Permit Number: C-1980-004
Mine Name: McClane Canyon Mine
Operator: ARC McClane Canyon, LLC

INSPECTION INFORMATION

This report documents the observations taken by the Division during a complete inspection of the McClane Canyon Mine. This inspection was also an Office of Surface Mining, Reclamation and Enforcement Complete Oversight Inspection. The inspection was conducted on November 29, 2023 by Clayton Wein of the Division. Thomas Medlin represented OSMRE during the inspection. ARC McClane Canyon, LLC (AMC) was represented by Chuck Silengo during the inspection. The weather was clear with a temperature of approximately 40° F. The ground was covered with snow.

Photo 7: The location where a piece of rebar identified in the embankment of the north office sump. The rebar was removed during the inspection.

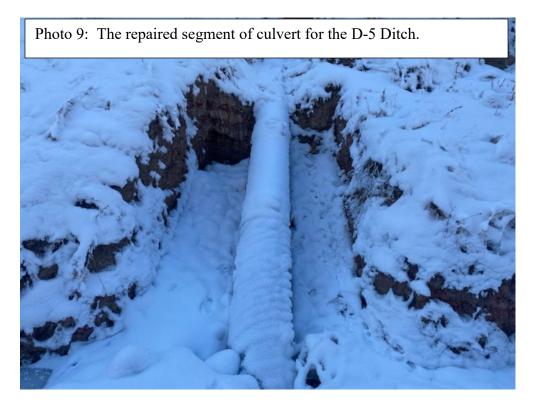
The north and south office pad sumps were holding frozen water in them. The silt fences placed at the sumps' outlets were in good condition. There were no indications of instability or erosion noted. A piece of steel rebar was removed from the embankment of the north office sump during the inspection (Photo 7). The rebar will be stored on the office pad with the other usable materials.
